Service Note		
Product	Description:	Service note no.
M6K,DB8 DB4	Floppy Disk drive isolation	712 10 1840

Remedy: This ECO is related to the floppy disk implemented in ECO 1828

Figur 1

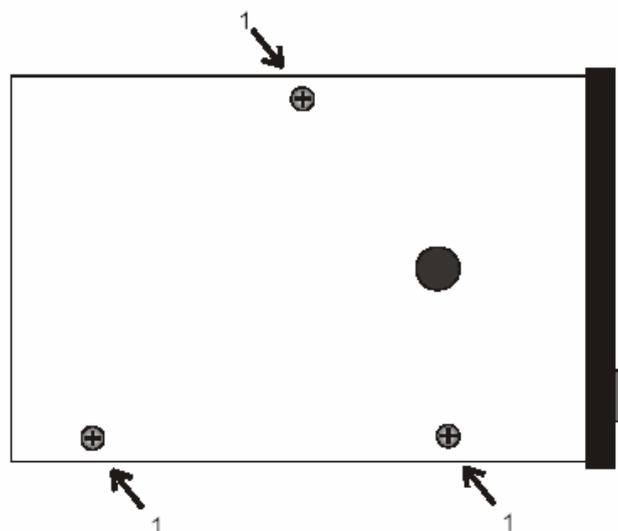
Symptoms: The power connector in the new Panasonic floppy disk has been changed to a type with a metal bracket. It is possible for this metal bracket to touch the floppy chassis and then make a connection between **CGND** and **DGND**. This causes ground loop problems, and the ground lift will not work probably.

1. Place the floppy drive bottom up.
2. Un-mount the 3 screws and remove the aluminum wrapping around the floppy drive to access the main print when "ERROR! REFERENCE NOT FOUND".

To avoid these problems we have to modify the Disk drives at TC by putting in 2 pieces of Mylar insulation.

Figur 2

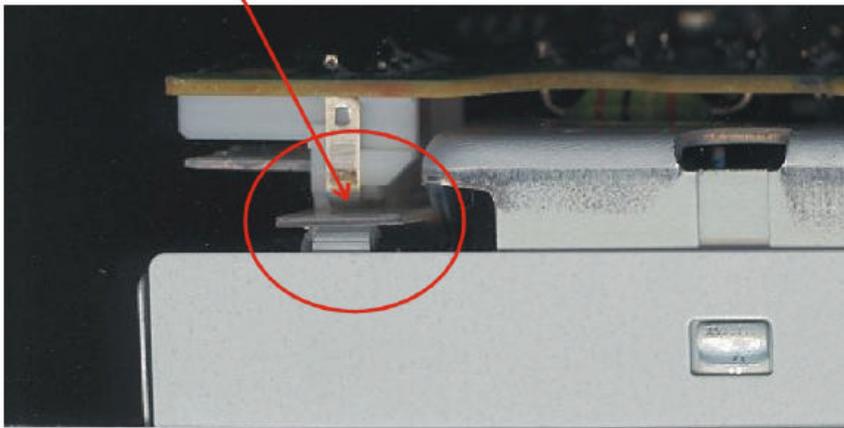
- Place the two self-adhesive Mylar isolation shield under the power connector as shown in fig.2 top picture. Then put another Mylar isolation shield on the bottom lid in the corner see the lower picture in fig.2.

Place 16x7 millimeter mylar here

Place 20x16 millimeter mylar here
